**SANTA FE COUNTY**  
**IFB#2016-0067-PW/BT**  
**CONSTRUCTION SERVICES FOR THE**  
**STANLEY CYCLONE CENTER ARENA**

**ADDENDUM #3**

**FIRE PROTECTION WATER PUMP EQUIPMENT AND PIT**  
NOT TO SCALE

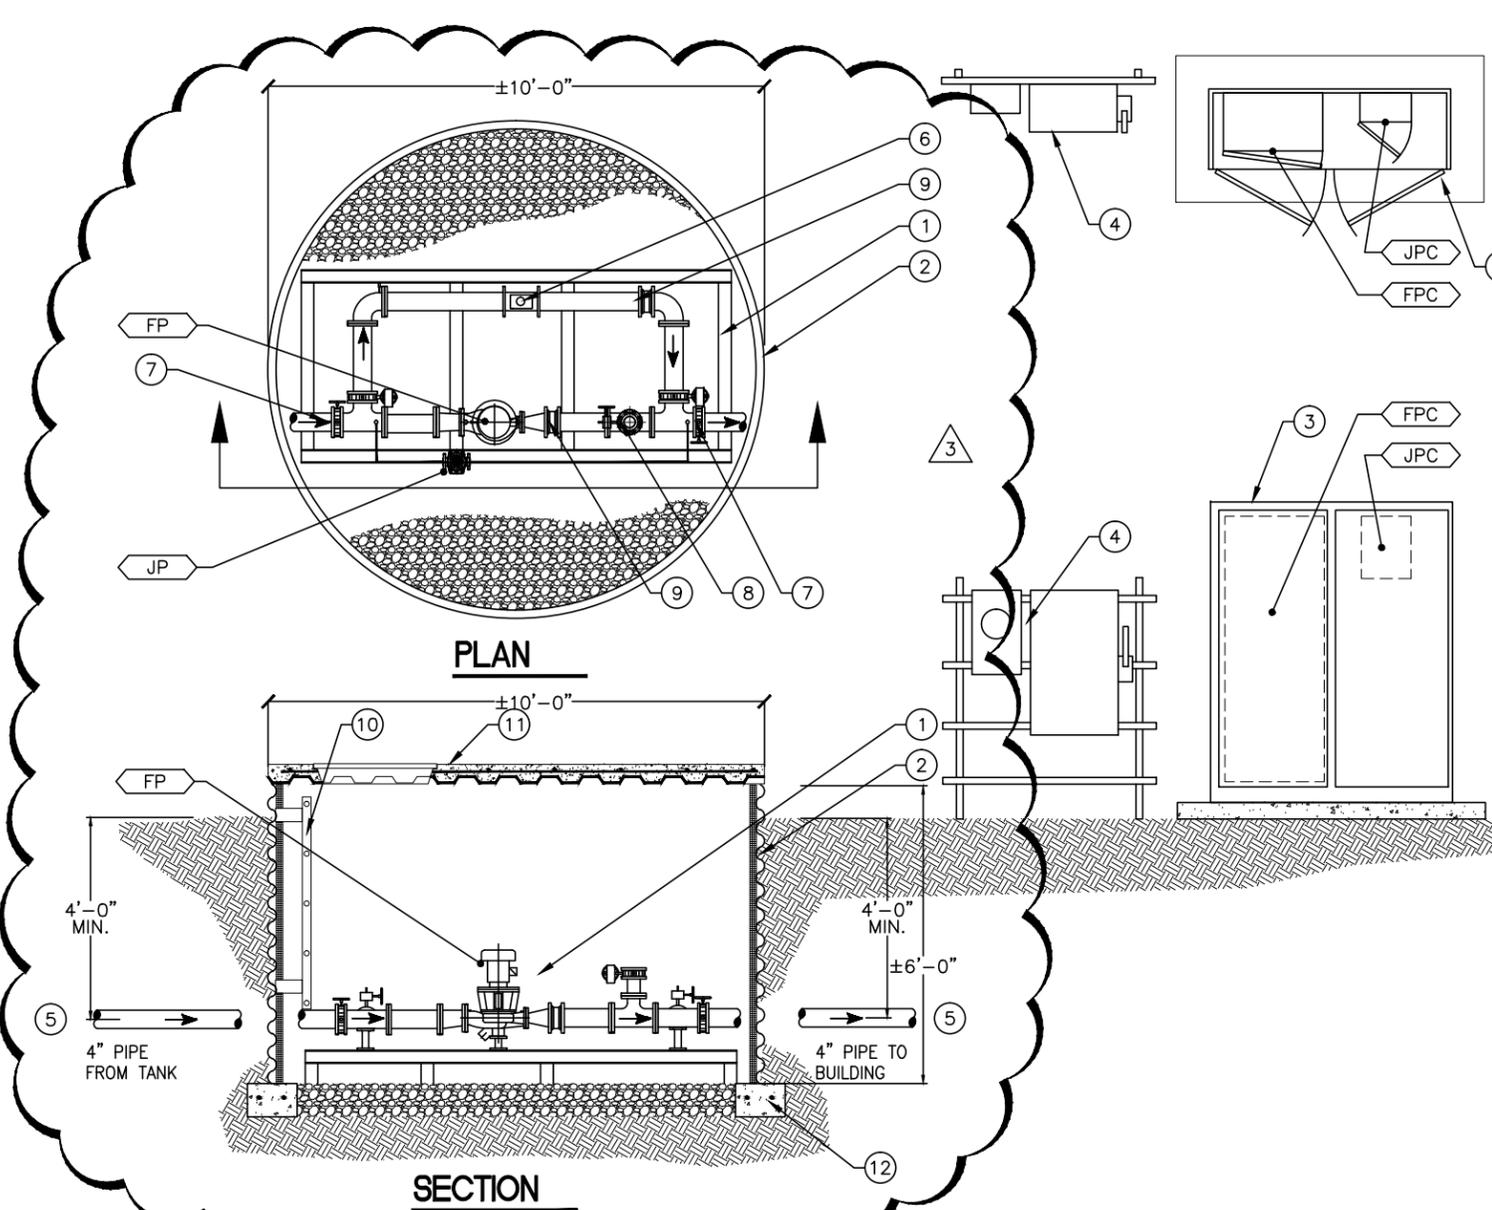
- Question# 2- Sheet FP-0.1 show dimensions for the new below grade pump equipment pit. Keynote #2 indicates that the pit is to be by others. Can you please provide Civil, Architectural and Structural design for this pit?

- Answer# 2- *Please see attached Fire Pump Pit Sketch – SK FP-0.1*
- Question# 3- Sheet CO indicates a new 8” water line servicing the proposed events center. Sheet C2 indicates the 8” water line is “by others”. FP-1.0 shows a new 4” fire service line to the building from the new fire pump/tank and a new 8” line to a fire hydrant out to Kinsell Avenue. Sheet SU1.0 only shows a new 1 ¼” domestic line. Can you please clarify if the fire service line to the new events center will be a 8” line per CO or a 4” line per FP-1.0?

1. NEW FIRE PUMP SKID ASSEMBLY IN EQUIPMENT PIT. SEE FIRE PUMP EQUIPMENT LIST FOR SPECIFICATIONS. MOUNT EQUIPMENT SKID IN PIT ON GRAVEL BASE. ENSURE THAT EQUIPMENT SKID IS STABLE FOR PROPER OPERATION.

2. INSULATED CORRUGATED STEEL EQUIPMENT PIT WITH INSULATED WEATHERPROOF CONCRETE COVER AND MANHOLE WITH LADDER. SIZE TO ACCOMMODATE NEW FIRE PUMP EQUIPMENT SKID AS SHOWN. FIRE PUMP EQUIPMENT PIPING SHALL BE A MINIMUM OF FOUR FEET BELOW FINISHED GRADE TO AVOID FREEZING. EQUIPMENT SHALL HAVE A GRAVEL FILLED BASE FOR DRAINAGE. FIELD VERIFY DIMENSIONS WITH FIRE PUMP EQUIPMENT MANUFACTURER PRIOR TO COMMENCING WORK.

11. STRUCTURAL METAL DECK EQUIPMENT PIT CAP WITH 3 INCH CONCRETE AND #3 REBAR REINFORCING AT 16 INCHES ON CENTER. PROVIDE MANHOLE WITH COVER.
12. CONCRETE FOOTING 8"x12" WITH TWO RINGS OF #3 REBAR REINFORCING FOR CORRUGATED METAL CULVERT.
